Work Order ID 67181

Item Name: Aft Crosstube Support Change

DART SERVICE INSTRUCTION

TO AMEND INSTALLATION INSTRUCTIONS IIN-D205-594 Rev. C (AND EARLIER) AND INSTRUCTIONS FOR CONTINUED AIRWORTHINESS ICA-D205-594 Rev. 2 (AND EARLIER)
REF. CANADIAN STC: SH03-6
REF. FAA STC: SR01742NY

FIGURE 1: INSTALLATION OF SUPPORT ON CROSSTUBE

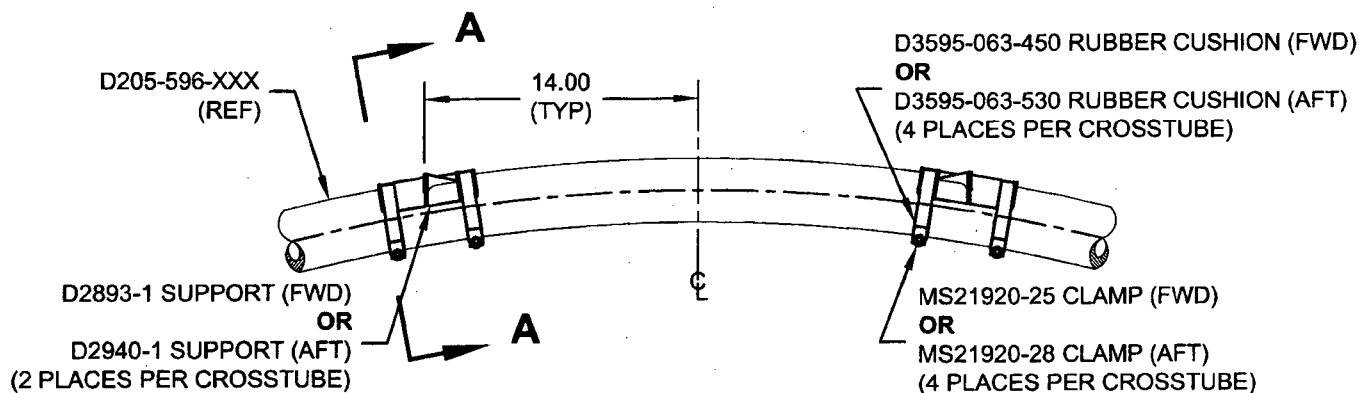
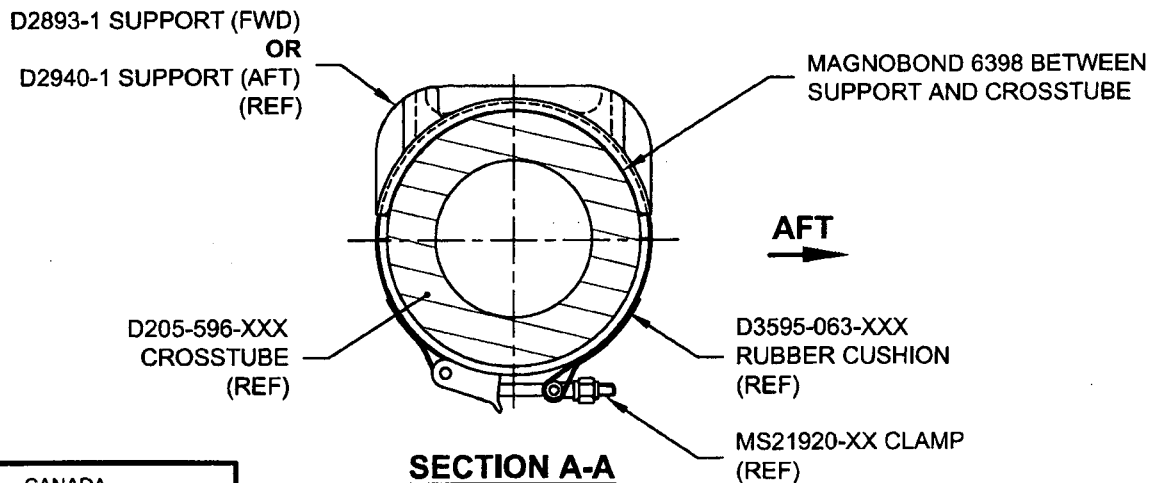
To prevent the supports from shifting on D205-596-101/-103/-105/-107 Crosstubes at CHG 001, the D2893-1 or D2940-1 Supports should be removed and re-installed as follows:

- Apply a 0.03" to 0.06" thick layer of Magnobond 6398 underneath D2893-1 or D2940-1 Supports and re-install the Supports on the crosstube as shown in Figure 1. Install a D3595-063-450/-530 Rubber Cushion on each MS21920-25/-28 Clamp. Position and secure the D2893-1 or D2940-1 Supports on the crosstube using MS21920-25/-28 Clamps. Torque clamps to 80-100 in-lb. Let the D205-596-101/-103/-105/-107 Crosstube Assembly cure before re-installing the crosstube on the aircraft.

- Note:** It is acceptable to substitute the MS21920-25/-28 with longer or shorter clamps to accommodate varying diameters. Ensure there is a minimum of 1.5 threads in safety on the nut.
